2006 Cadillac STS-V: Service Bulletin: #07-07-30-002: 6L80 Automatic Transmission Busy Shifting, MIL Illuminated, DTC P1751 Set

#07-07-30-002: 6L80 Automatic Transmission Busy Shifting, MIL Illuminated, DTC P1751 Set (Replace Control Valve Body Spacer Plate) - (Jan 30, 2007)

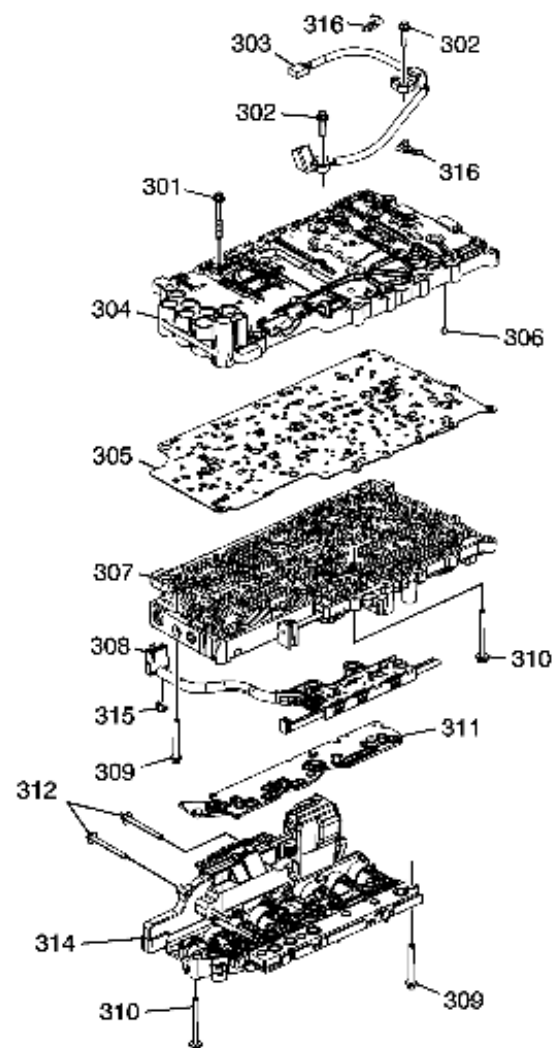
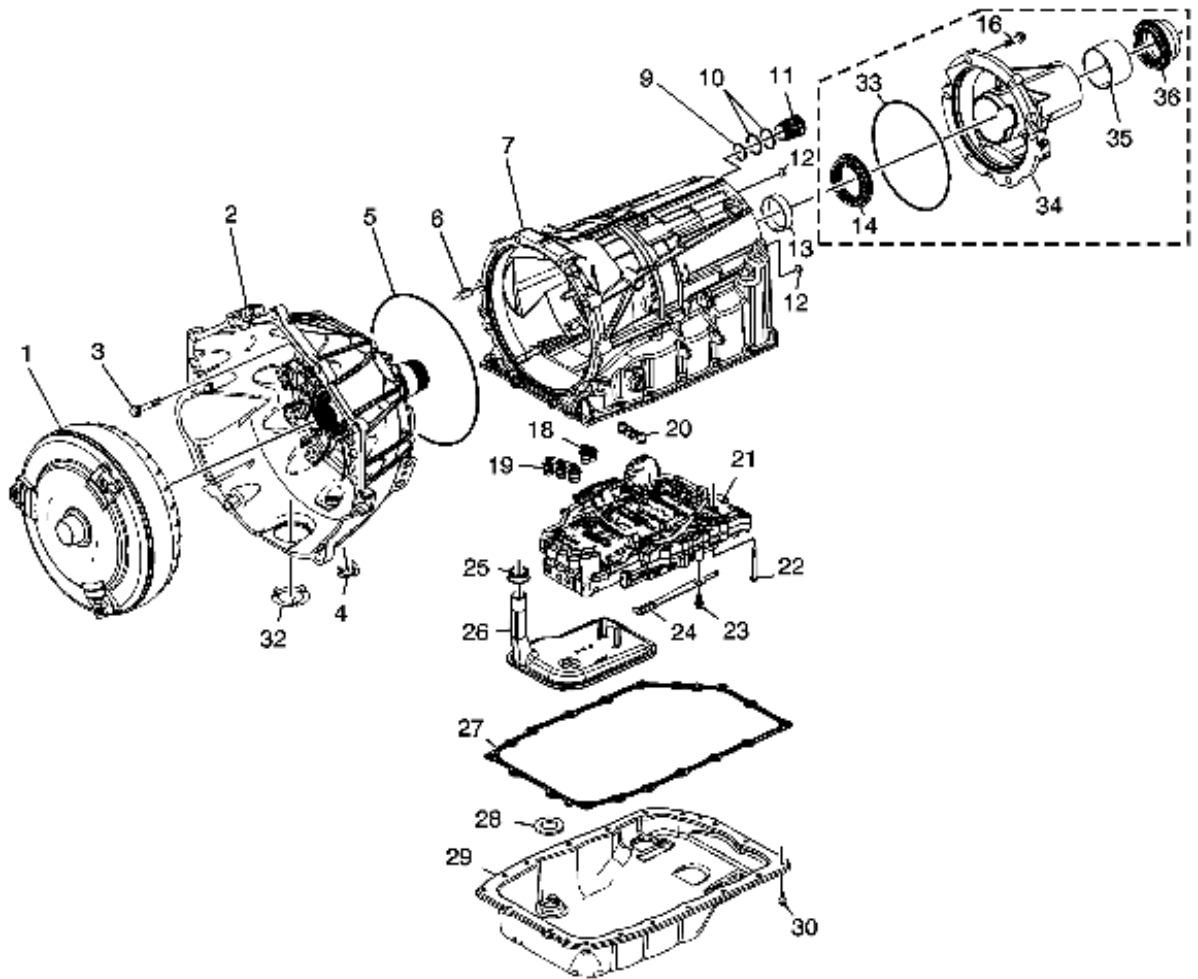
This condition may be caused by an undersized hole or debris in the control valve body spacer plate (305).

To correct this condition the control valve body spacer plate (305) must be replaced. The electrical connector seals (9, 10), fluid pump seals (18, 19), center support seal (20) and the filter plate assembly (311) should also be replaced. These parts are included in the filter plate kit listed below.

Changes to the control valve body spacer plate were implemented November 4, 2006 in transmission assemblies to prevent this condition.
